Product / Process Change Notification (PCN)

PCN #: PCN_conWTB125_20231220

Affected Series: WR-WTB125 6531xx131822

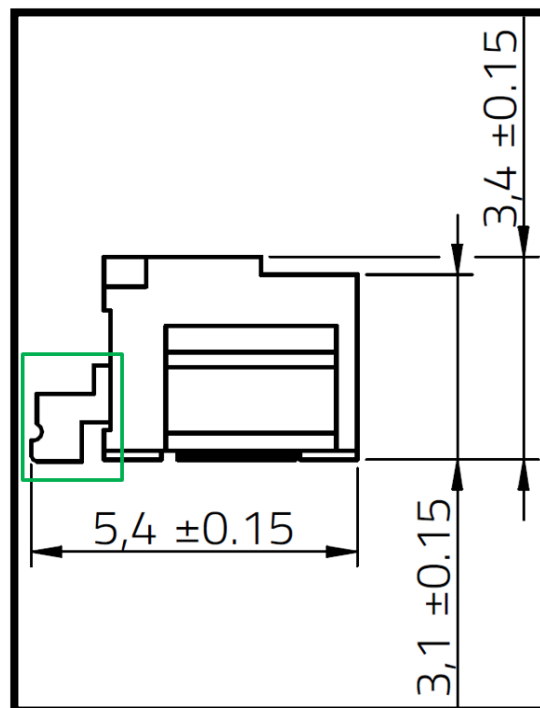
The shape of the pin on the WE Datasheet is incorrect in comparison with the physical part and should be corrected:
